RE: Sherwin-Williams/Hilliards Creek Site - Kirkwood Lake Voorhees Township and Lindenwold Borough, New Jersey Administrative Order Index No. II CERCLA-02-99-2035

Response to USEPA Comments: Kirkwood Lake Investigation Report - Evaluation of Sampling Results (dated April 30, 2010), and Supplemental Remedial Investigation Work Plan, Kirkwood Lake Sediment and Soil Sampling and Residential Property Soil Sampling

KIRKWOOD LAKE TRANSECT SEDIMENT CROSS-SECTION DATA TABLE KWT-20

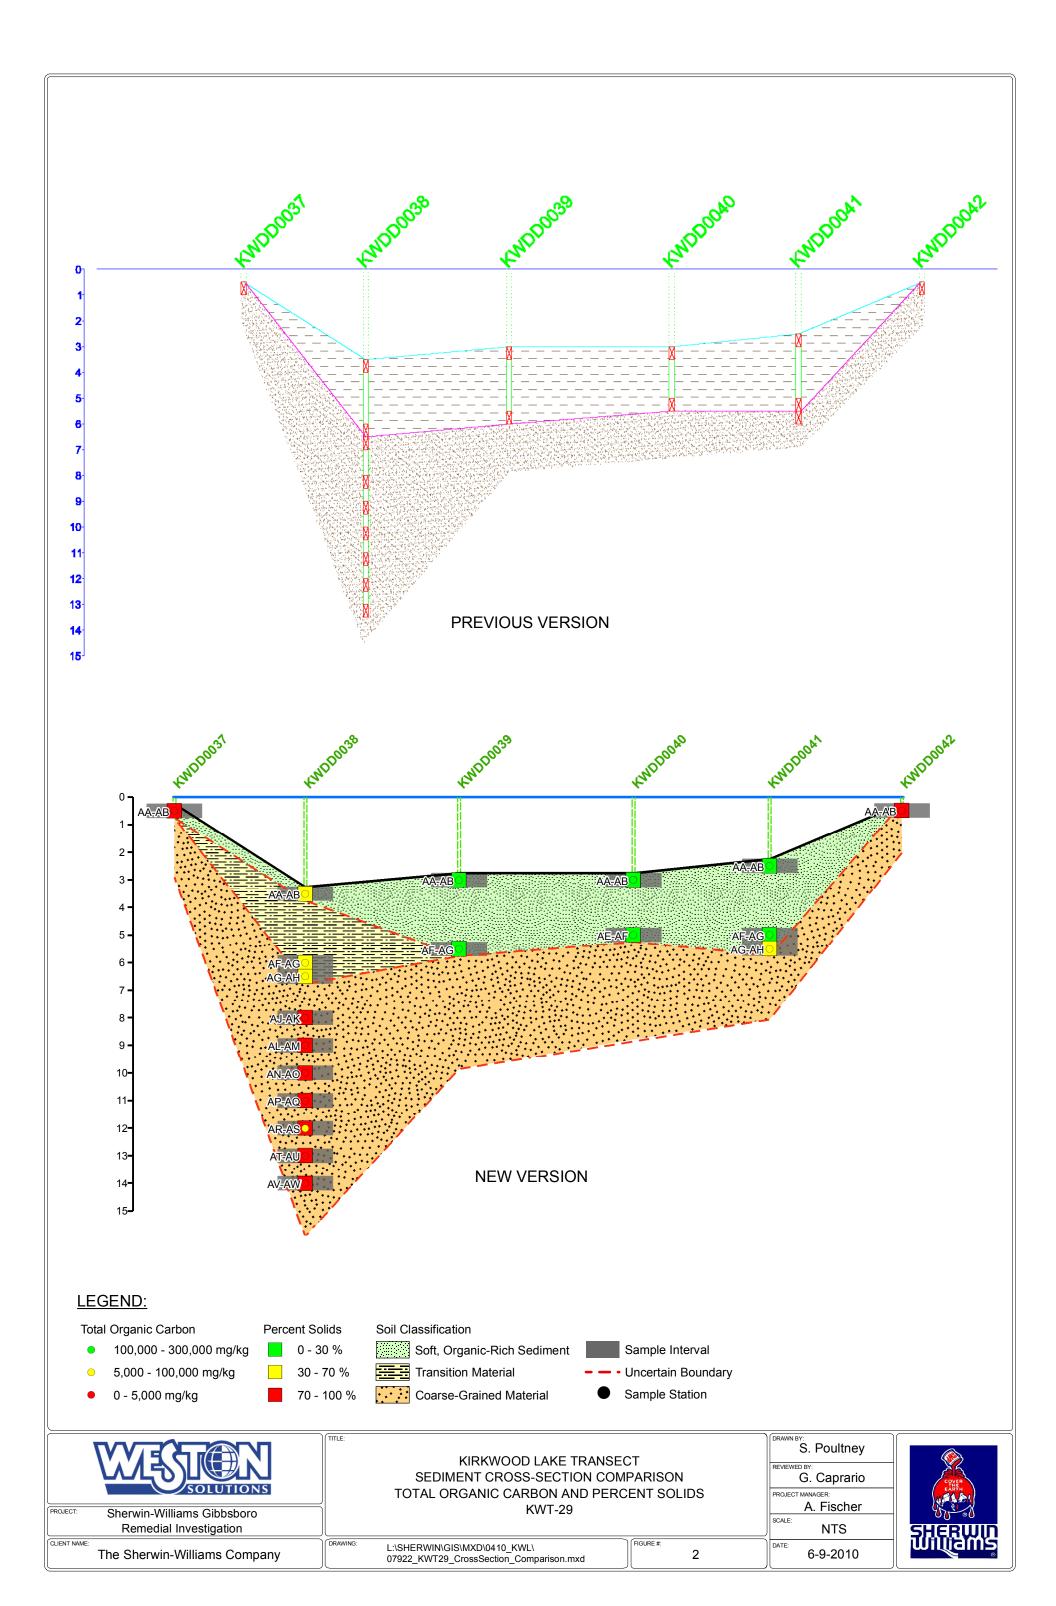
The revised interpretation of the physical characteristics of the sediment and soil beneath Kirkwood Lake is reflected in Figures 1 and 2, which compare and contrast the original and revised cross-sections for transects KWT-20 and KWT-29. These samples were selected for illustration purposes because they provide examples of samples originally interpreted as being collected from the coarse-grained material, but that are now believed were actually collected from the transition material, as well as samples that were collected from the coarse-grained material. The revised interpretation for all Kirkwood Lake transects will be provided when the data analysis report is submitted to the EPA following the next phase of sampling.

As shown on Figure 1 (KWT-20), five samples (KWDD0025 AA-AB, KWDD0025 AB-AC, KWDD0026 AA-AB, KWDD0028 AG-AH and KWDD0029 AA-AB) were originally reported as being collected from the coarse-grained material. However, a more detailed review of the percent solids and organic carbon measurements supports a conclusion that only one of these samples, KWDD0029 AA-AB, was actually obtained from the coarse-grained material. This sample contained the high percent solids (80%) and low organic carbon (3,000 mg/kg) values that are typical of the coarse-grained material. However, the other samples from KWT-20 that were presented in the 2009 Kirkwood Lake report as being from the coarse-grained material did not exhibit these characteristics:

- The percent solids measurement from the two samples obtained at location KWDD0025 (approximately 60%) were less than those typical of the coarse-grained material, and the organic carbon measurements (approximately 2% or 20,000 mg/kg), while less than those typical of the soft organic-rich sediment, were much higher than that typical of the coarse-grained material. Based on these observations, it has been concluded, as shown in the revised cross-section, that these samples were obtained from the transition material.

- A similar observation is valid for sample KWDD0026 AA-AB. Although it had a relatively high solids content (approximately 73%), its organic carbon content (approximately 5%) is much greater than would be predicted if the sample was obtained from the coarse-grained material. Based on these observations, the revised interpretation is that the sample was obtained from the transition material.

- The solids (approximately 16%) and organic carbon (approximately 25%) contents of KWDD0028 AG-AH support a conclusion that it was obtained from the soft organic-rich sediment, not the coarse-grained material. As shown on Figure 1, this reinterpretation of the physical characteristics of the sediment supports a conclusion that the soft organic-rich material is deeper in this location than previously believed.

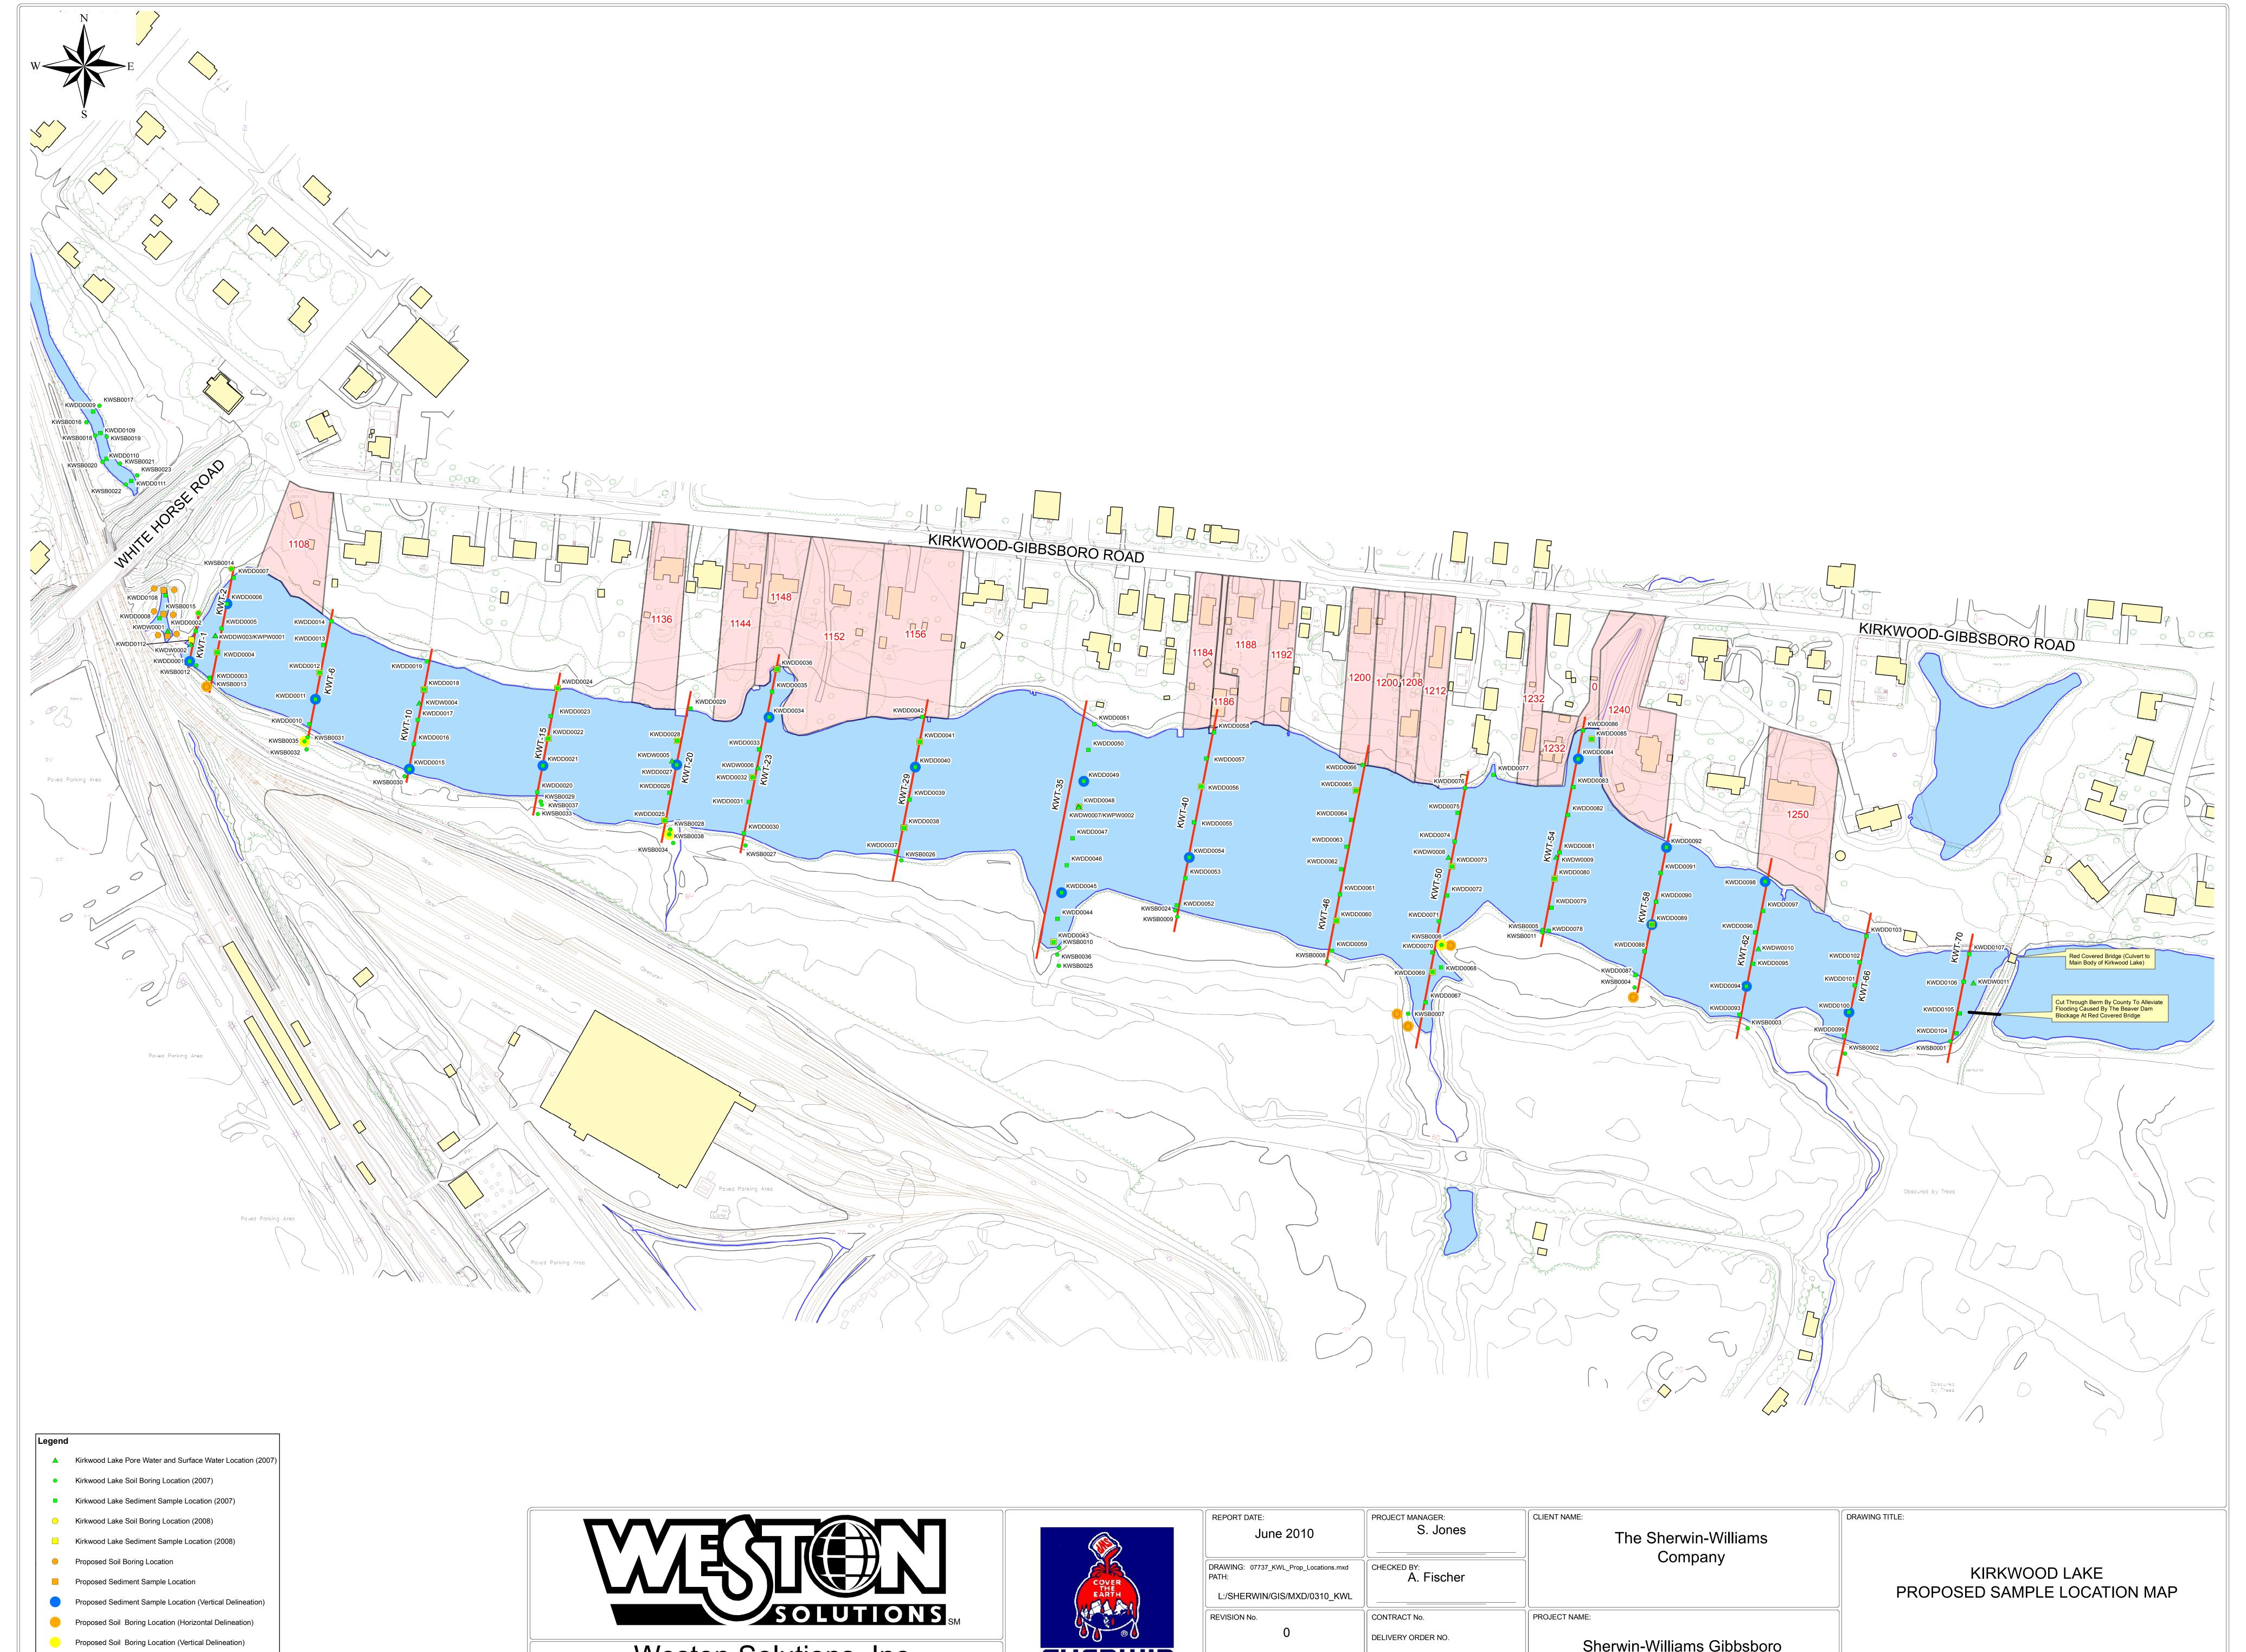
The revised cross-section presented in Figure 2 (KWT0029) further illustrates the variation in the physical characteristics of the soft organic-rich sediment, the coarse-grained material and the transition material:

Samples obtained at depth at location KWDD0038 (KWDD0038 AJ-AK through KWDD0038 AV-AW) provide typical characteristics of the coarse-grained material, with percent solids measurements ranging from approximately 76 -81%, and organic carbon measurements of approximately 0.5% or lower (note that sample KWDD0038 AR-AS had an organic carbon content of 0.501%).

- Samples from the shallower intervals, in KWDD0038, contain a wide range of both percent solids and organic carbon measurements. The percent solids measurements in these samples range from 34.6 63.6%, while the organic carbon content ranges from 7,110 57,600 mg/kg. Despite the range in both percent solids and organic carbon content, it can be concluded from the results that none of these samples has the characteristics of either the soft organic-rich sediment or the coarse-grained material and, therefore they have been classified as being from the transition material.

- Sample KWDD0041 AG-AH provides another example of the need for professional judgment in characterizing the material in the sample. This sample was originally presented as being collected from the coarse-grained material. However, it has a relatively low solids content (32.1%) and high organic carbon content (99,100 mg/kg). Although both measurements are slightly outside the typical limits assumed for the soft organic-rich sediment (30% solids and 100,000 mg/kg organic carbon), the variation is small enough that the sample has been classified as being collected from the soft organic-rich sediment.

DRAWING: 07737_KWL_Prop_Locations.mxd PATH:	CHECKED BY: A. Fischer
L:/SHERWIN/GIS/MXD/0310_KWL	
REVISION No.	CONTRACT No.
0	DELIVERY ORDER NO.
WORK ORDER No.	DRAWN/MODIFIED BY: Lynes
20076.022.080.0005	DATE CREATED: 03/17/2010

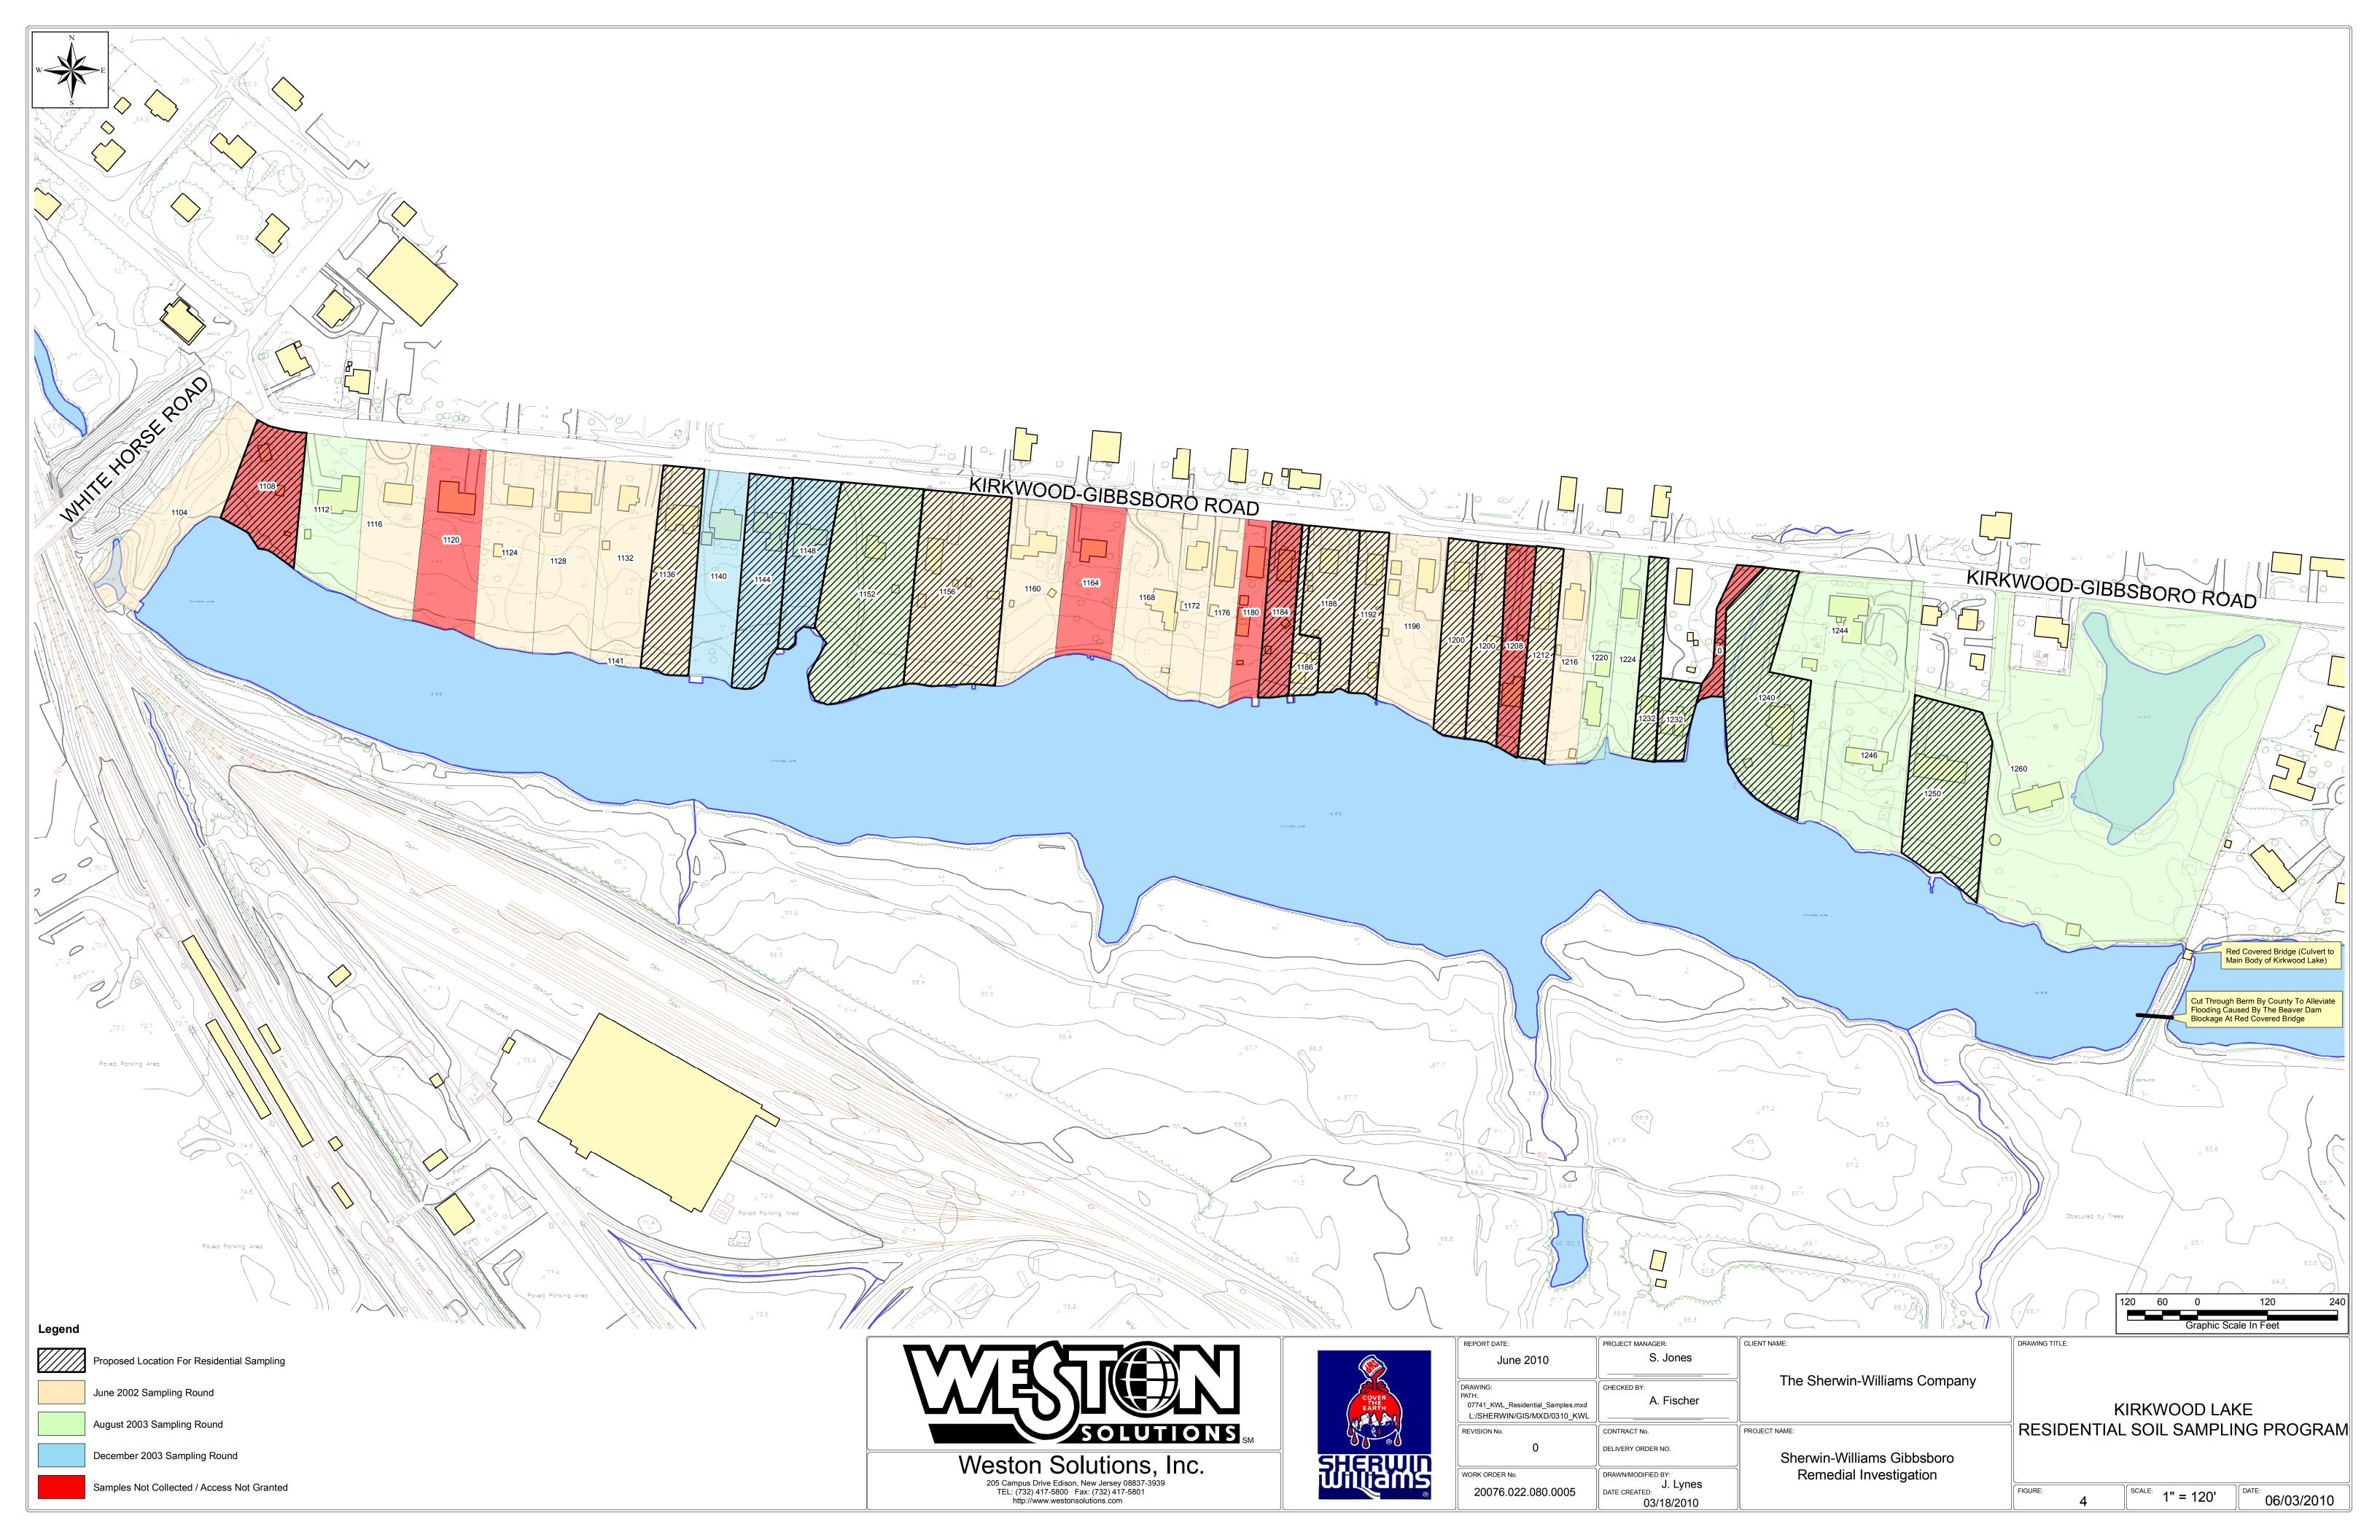
Sherwin-Williams will collect sediment samples from the locations identified by EPA in Table 3 of its comment letter. The locations are shown on Figure 3.

As requested by EPA, Sherwin-Williams will collect sediment and soil samples at three locations in the Cooper River: the first sample immediately below the Kirkwood Lake dam, the second sample halfway between the dam outfall and the culvert that runs under White Horse Road, and the third sample before the culvert that runs under White Horse Road. These samples will all be collected downstream of the Kirkwood Lake Dam and before the culvert that runs under White Horse Road and the sample locations are shown on Figure 3.

A horizontal delineation boring will be installed approximately 10 feet east of KWSB0006 (away from the shoreline), as shown on Figure 3. Samples will be collected from the 0.0'- 0.5' and 2.0'- 2.5' intervals and any additional intervals where arsenic or lead were found at a concentration greater than the RDCSRS in the vertical delineation boring. These samples will be field screened with the XRF. If neither arsenic nor lead is found at a concentration greater than the RDCSRS, the sample(s) collected from the step-out boring will be sent to the laboratory for analysis.
